WOLF CREEK

ET 07-0032

Subject: Docket No. 50-482: Response to NRC Requests for Additional Information Related to Wolf Creek Generating Station License Renewal Application Time-Limited Aging Analysis Audit Question

**Wolf Creek Nuclear Operating Corporation (WCNOC) Response to NRC Requests
for Additional Information RAI 4.3-1**

Figure 3: Membrane-plus-Bending Stress Intensity Range

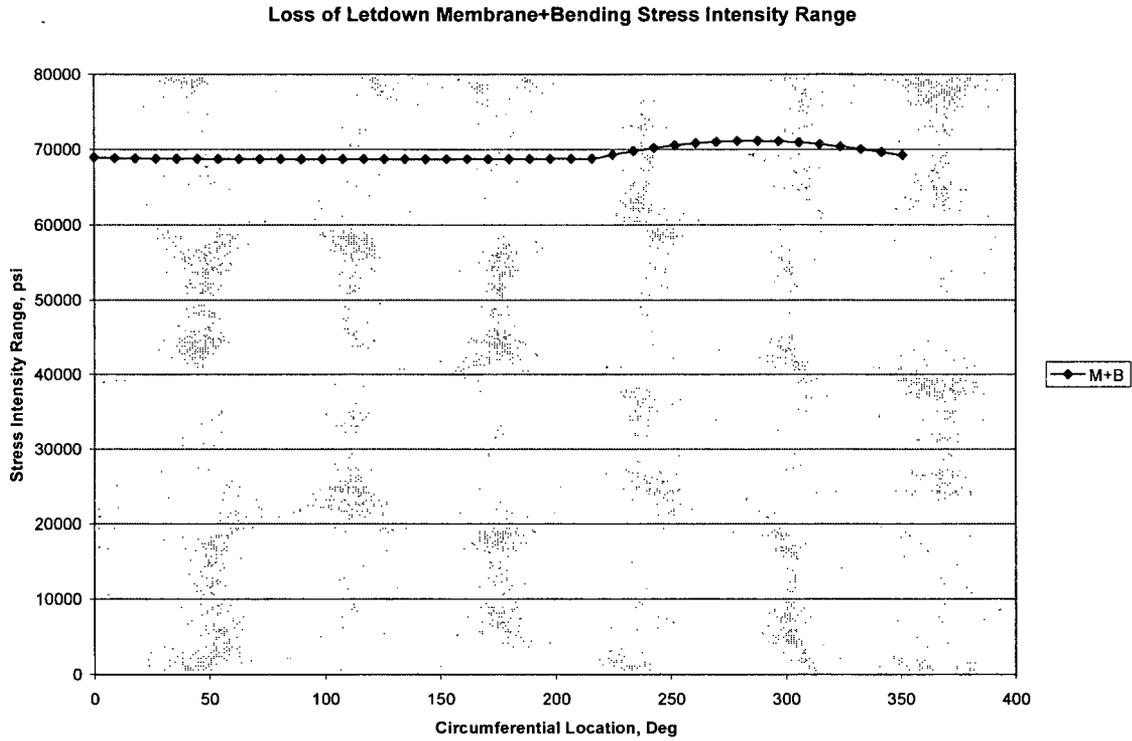
The peak stress intensity range for the same transient computed by a 3D finite element analysis was less than 71.2 ksi per Figure 3, with a maximum Ke of 2.40 (Figure 4) and a corrected stress range of less than 252 ksi (Figure 5).

Figure 6: Membrane-plus-Bending Stress Intensity Range

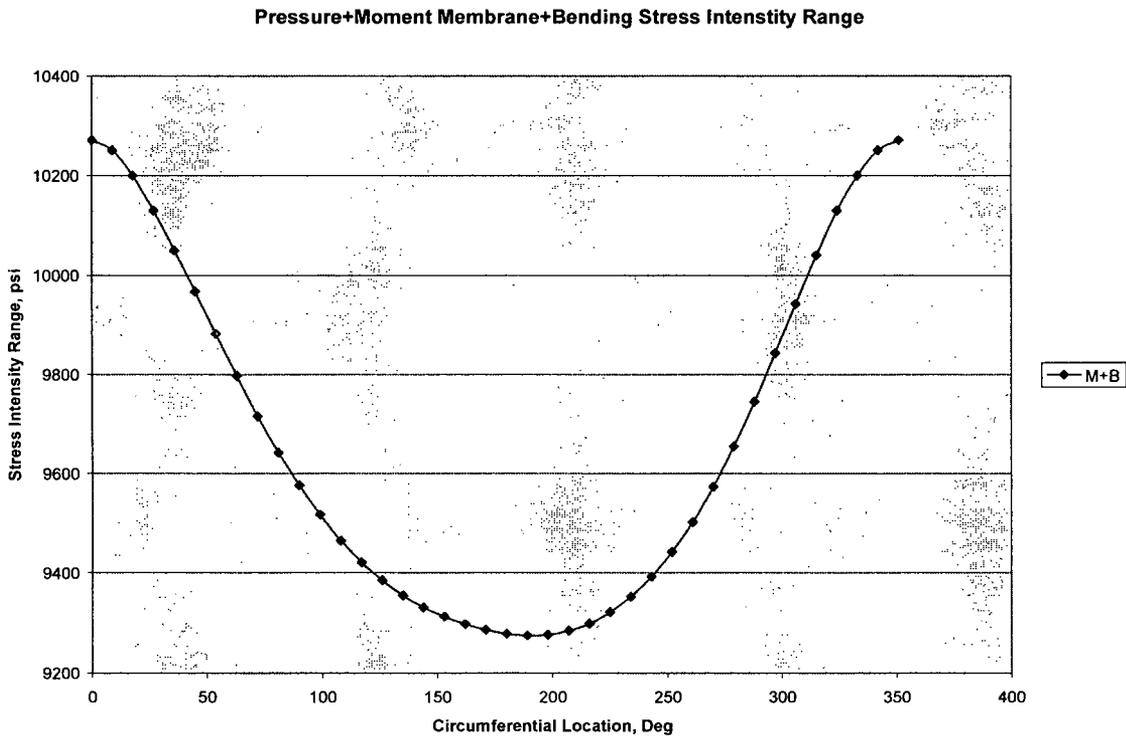
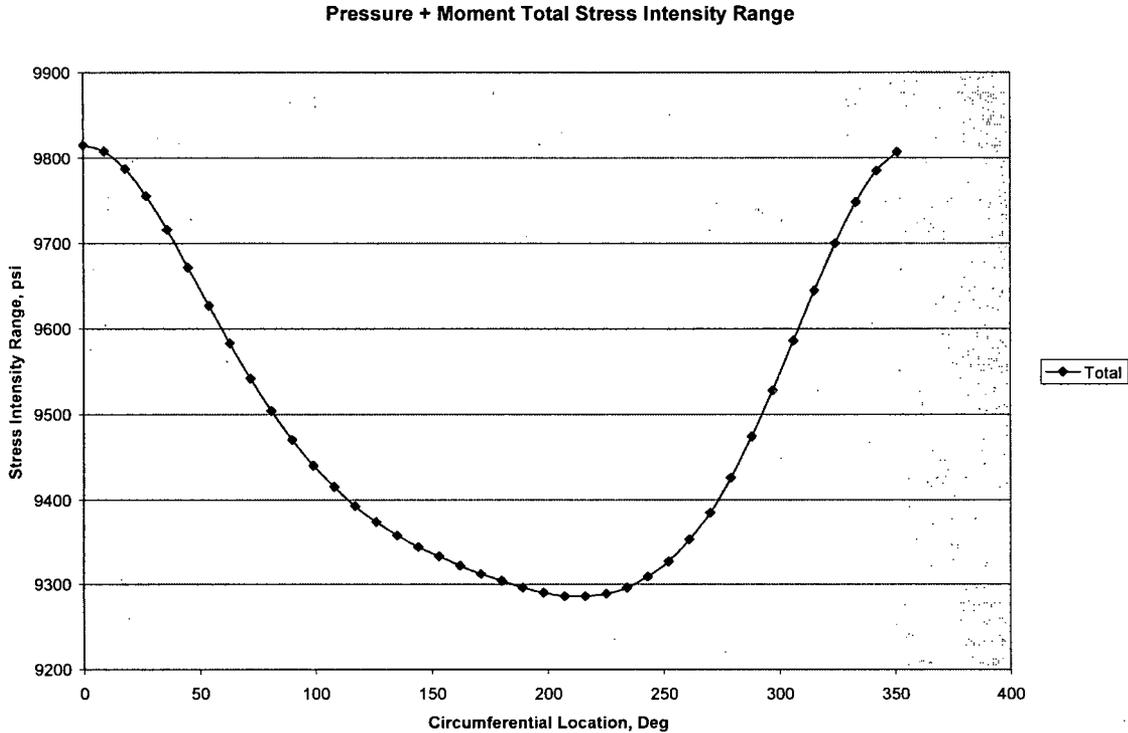
The peak stress intensity range for the same condition computed by a three-dimensional finite element analysis was less than 11 ksi per Figures 6 and 7.

Figure 10: FatiguePro Fatigue Details Table for Transient 1

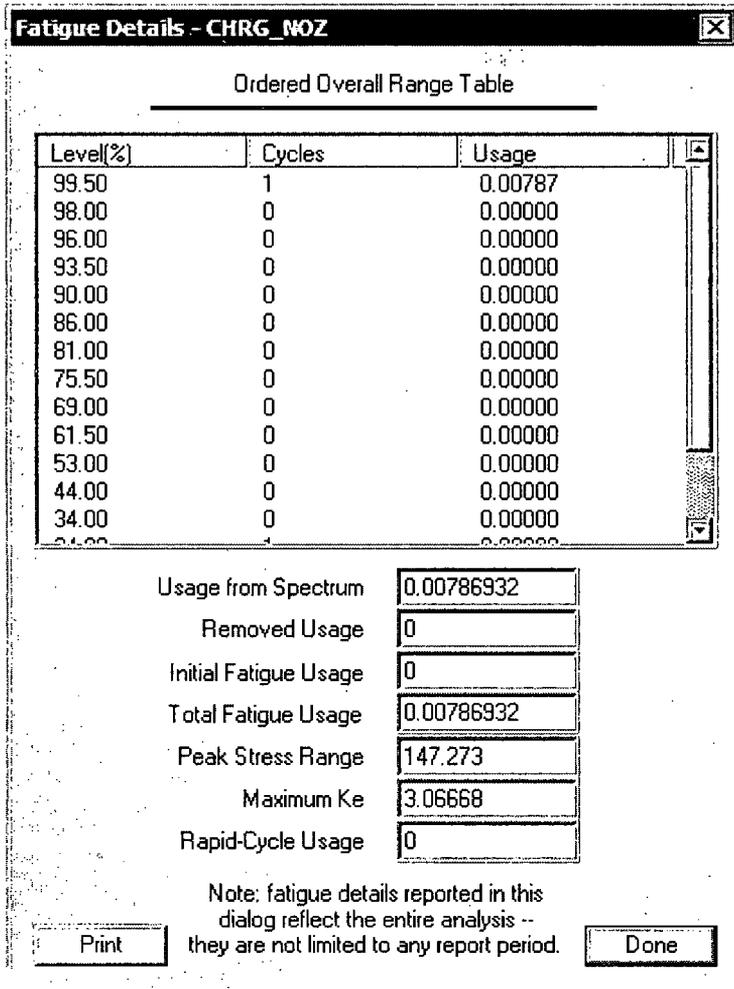
From that report, you can see that the fatigue usage is determined by a single stress pair, with a (total) stress intensity range of 147.3 ksi. A corresponding Ke factor of 3.067 is applied, giving a usage factor of 0.00787. (Note that the stress intensity range for the simulated cooldown/heatup transient is too small to have a significant effect on the computed fatigue usage.) The local temperature transient is shown in Figure 11. Figure 12 shows the resulting stress history, with the fatigue-significant portion zoomed-in in Figure 13.

The peak stress intensity range for the fast Loss of Letdown transient computed by FatiguePro was 147.273 ksi with a maximum Ke of 3.07 (see Figure 10). Multiplying the linear elastic stress range by Ke results in a corrected stress range of 452 ksi.
